WHITEMARSH TOWNSHIP PLANNING COMMISSION

MEETING OF JULY 28, 2020 6:00 PM

- Review (continued) SLD #05-14; 901 Washington Partners, LP/901 Washington Street
Revised Preliminary Plan; 62 Townhomes

**Reference: RIVERplace
901 Washington Street Townhomes
Zoning Ordinance Compliance Review and Preliminary Plan Review Responses
Whitemarsh Township, Montgomery County, PA
Nave Newell No. 2009-134.05**

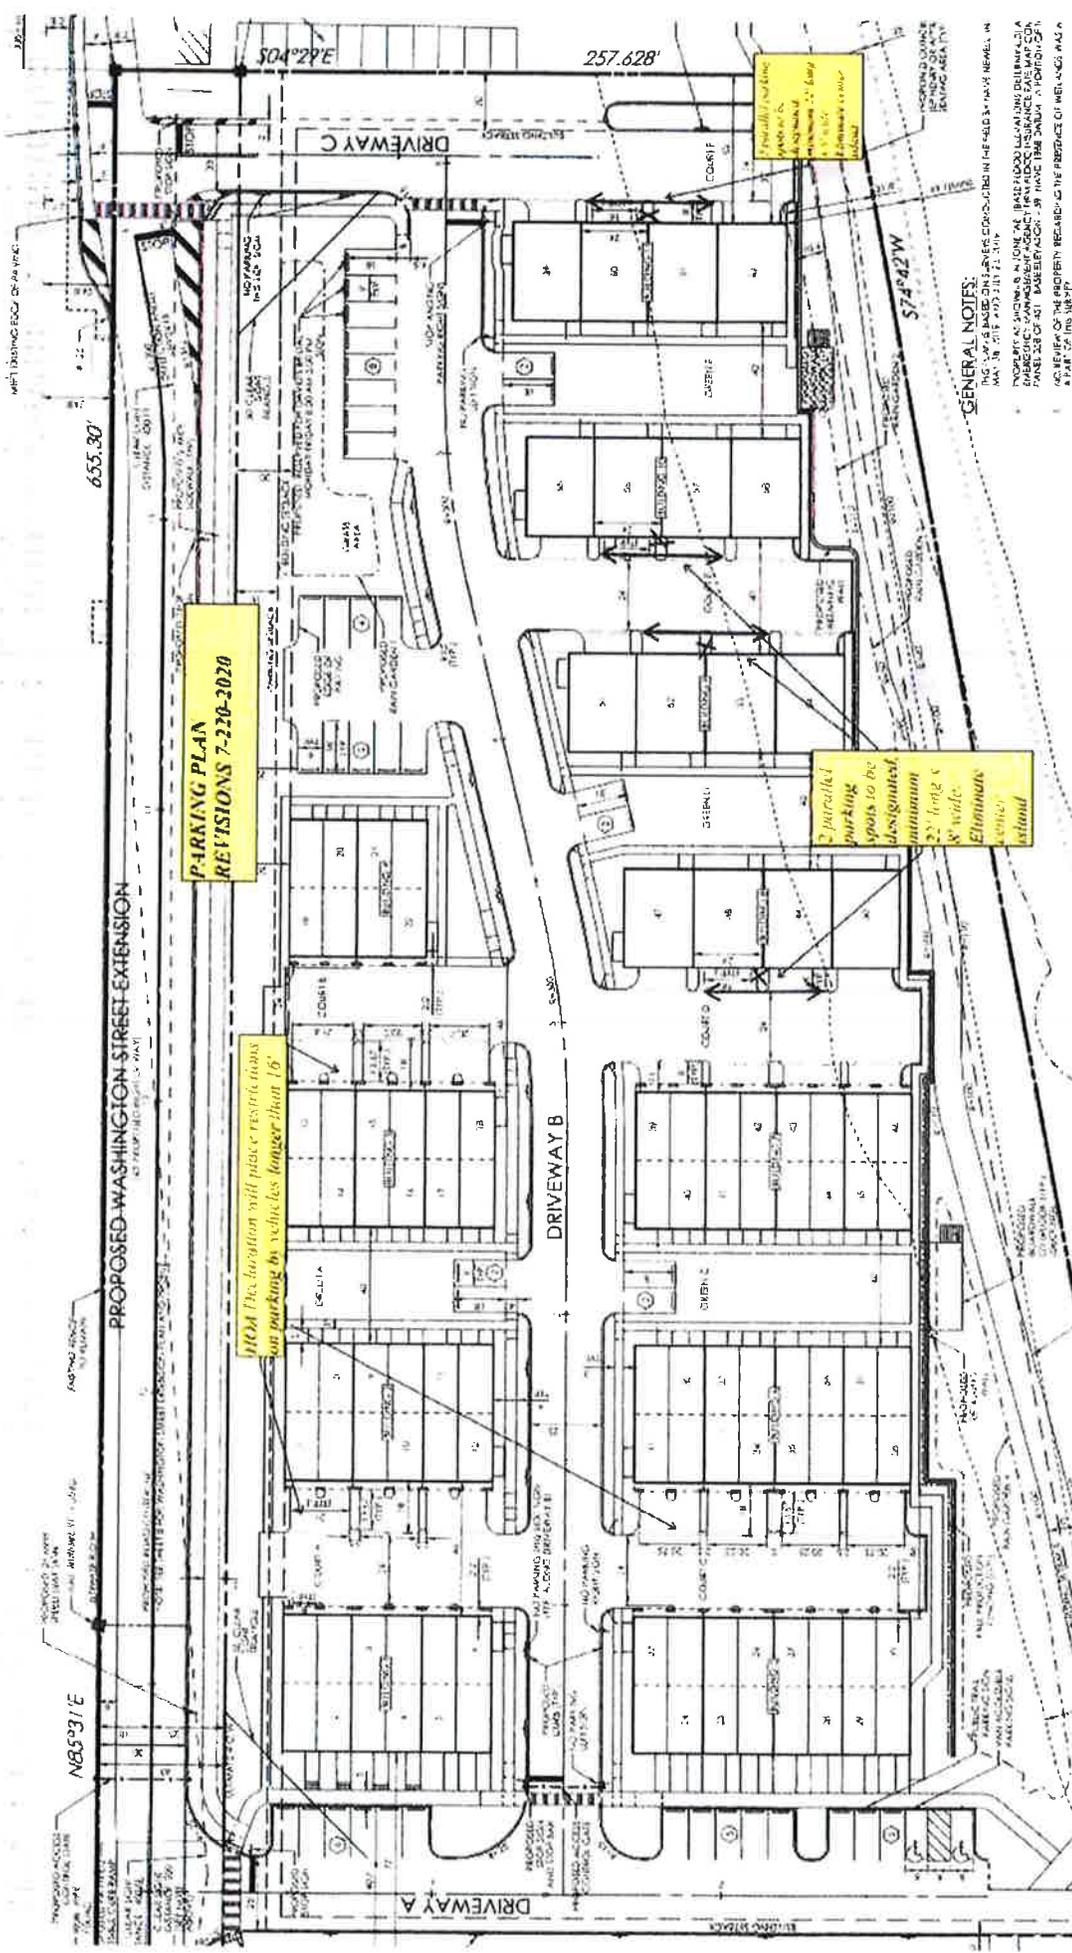
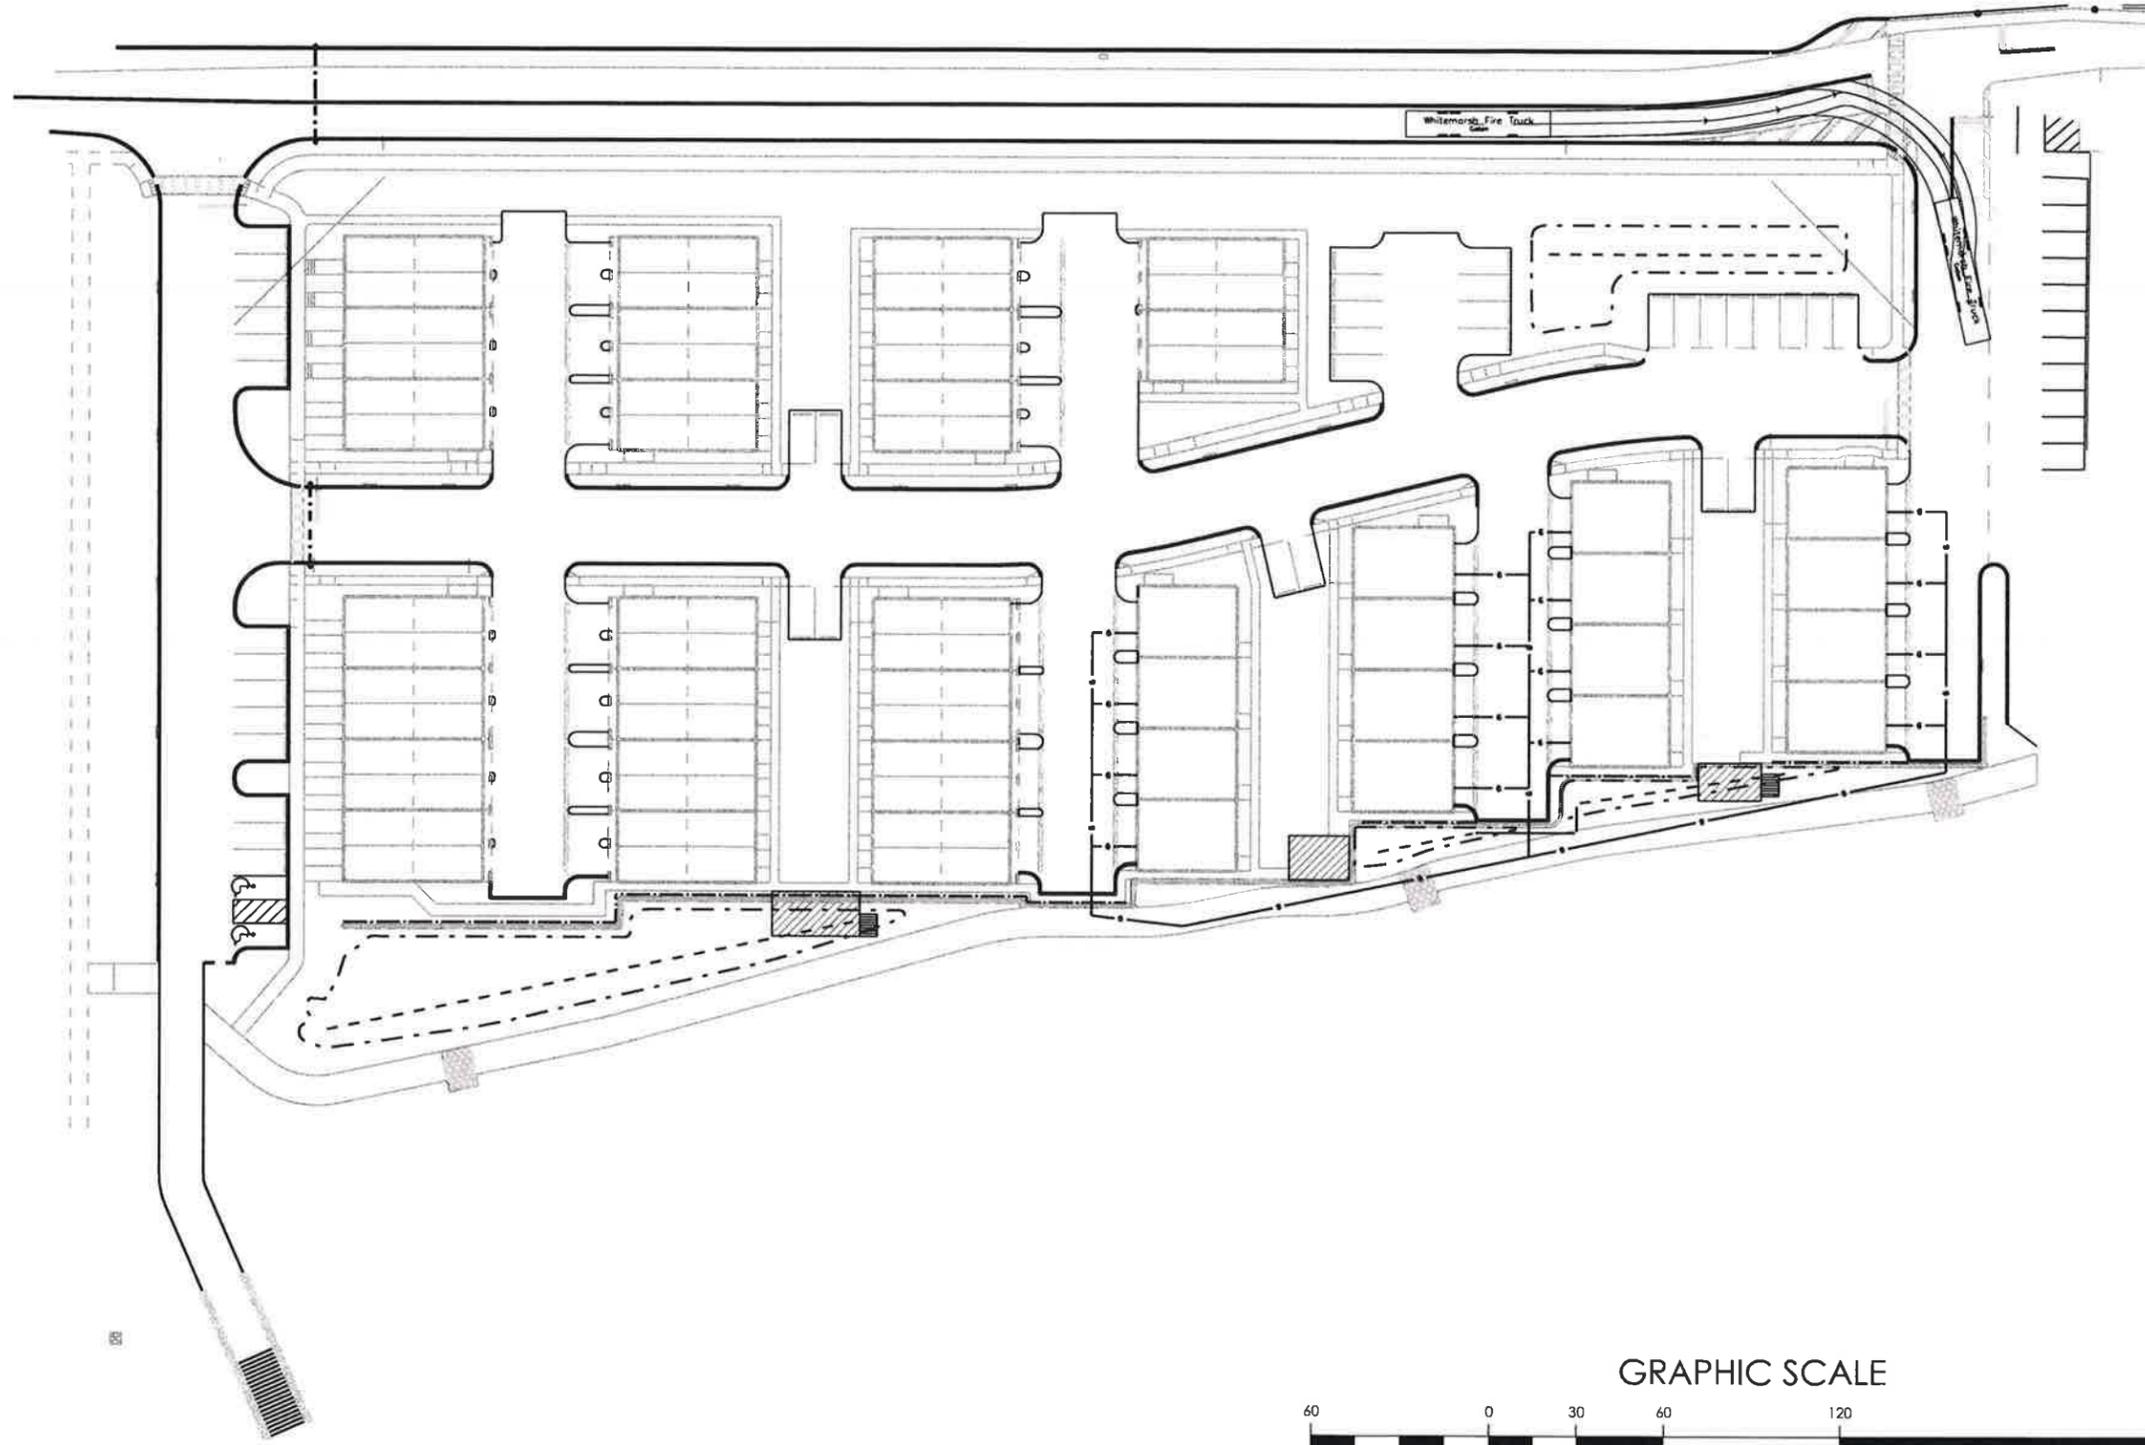
New Comment: The space in front of the garage doors for units 7 through 18 and 31 through 46 should be increased from 18 feet to a minimum of 20 feet from face of the garage door to the end of the separator between each pair of units. As is, it will be difficult to maneuver into/out of the single bay garages for units 1 through 6 and 19 through 30 if the spaces on the opposite side are occupied. The 8' x 20' parallel parking space in front of the garage doors for units 47 through 62 is not an adequate length. The separator between each unit must be eliminated so as to provide parallel parking spaces dimensioned 8' x 22' for each unit. These spaces should be striped so as not to cause confusion between adjacent neighbors. The spaces behind units 39 through 46 cannot be used for parking in any position. The HOA documents should reference that parking is only allowed in a designated parking space. While not opposed to on-street parking, the available curb space along Driveway B and the need to provide safe sight distance for vehicles exiting from Court C, D and E and from the three pairs of parking spaces at Green C, D and E indicates on-street parking will be limited to two spaces in front of units 31 and 39 and one space in front of units 47, 51 and 55 for a total of seven on-street parking spaces. Should on-street parking exceed these numbers, the HOA must be prepared to sign and designate individual parallel parking spaces along Driveway B.

2 parallel parking spots to be designed minimum 22' long x 8' wide. Elevation vehicle without

7 Parallel parking spots to be designed minimum 22' long x 8' wide. Elevation vehicle without

Response: *The plan has been revised to provide private driveways for most of the units. Units 7 through 18 and 31 through 46 will now have private driveways behind their garages plus all of the townhouse dwellings lots 47 through 62 will have a private parallel parking space in front of their garage doors. The HOA documents will include language prohibiting vehicular parking in the alleys behind garage doors which don't have private driveway spaces. In addition, with the widening of Driveway B to 25' in width, on-street parking will now be permitted on the south side of that roadway and signage will prohibit on street parking on the north side of that road.*
